S-21 Apparels Ltd. (11452)
Spencer Design Ltd (10074)
Fariha Accessories Int. Ltd.

Plot # 276, Narshingapur, Ashulia, Savar, Dhaka
(+23.92962N, 90.30895E)

31.MAY.2014

Priority 2 Concern

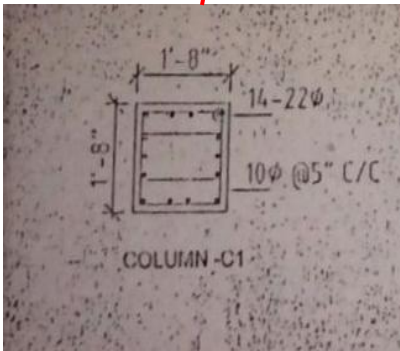
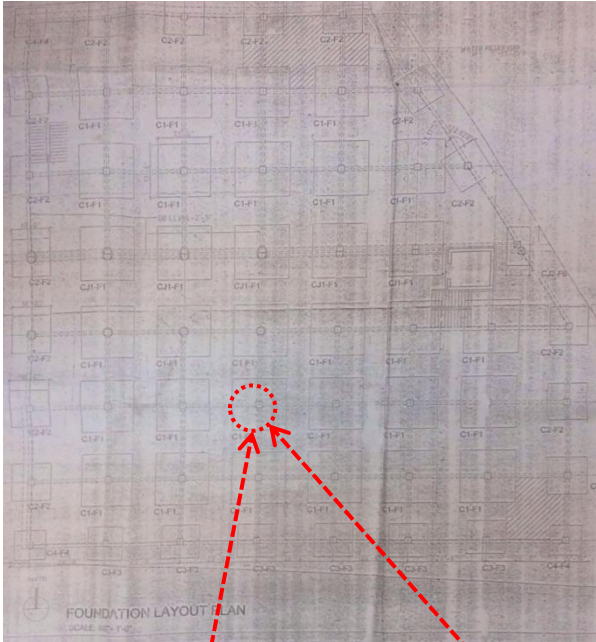
Based on the load rundown analysis of the building with 8 floors, as per Building Permit drawing, it gives a YELLOW status result for all checked columns that have similar loading conditions and designs. This requires that all floor loadings must be carefully monitored and loading plans provided which must then be strictly maintained.

Based on the load rundown analysis of the building with the current existing 4 floors, the current building operates well within structural limits.

Column to be checked

Dining room

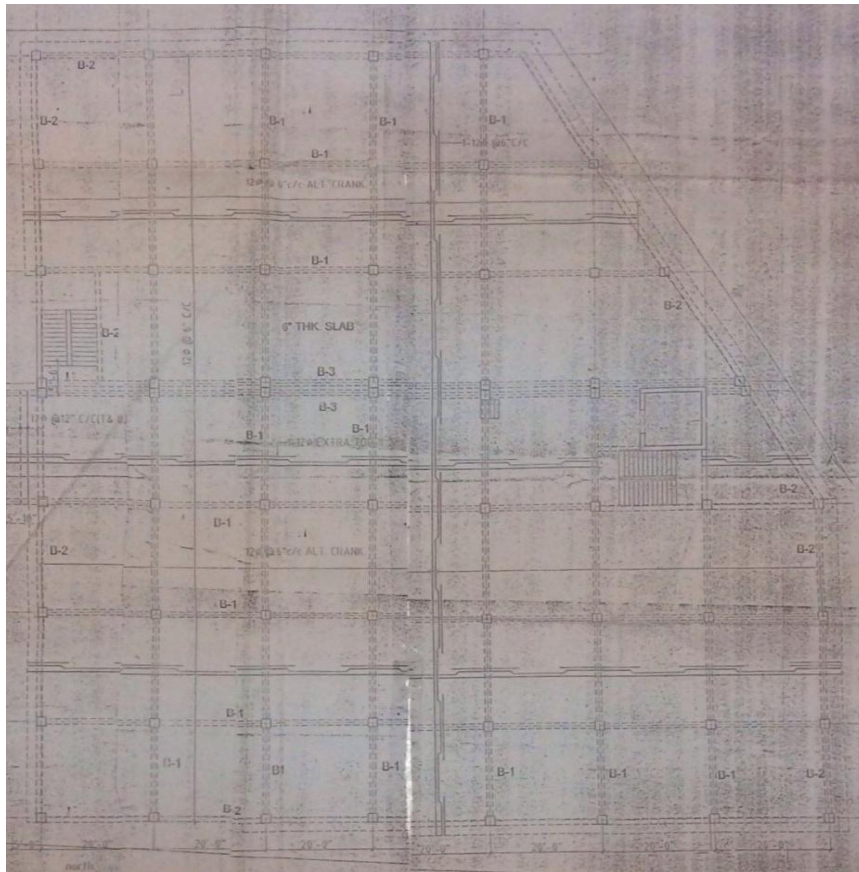
The dining building appears to be a temporary structure. There are no structural records to show the structural layout or connection details.

The steel beams and columns are very small and don't have any longitudinal bracing and appear corroded.

We require that these items be investigated in a Detail Engineering Assessment

5	1st Priority 3 - The structure for the dining building needs to be reviewed and longitudinal bracing and connections improved.	The detailed design for the Dining Building to be fully reviewed to verify the lateral stability under wind loading.	6-months
6	2nd Priority 3 - There is no waterproofing provided on the existing roof.	Provide and maintain a proper waterproofing layer on the roof level.	6-months
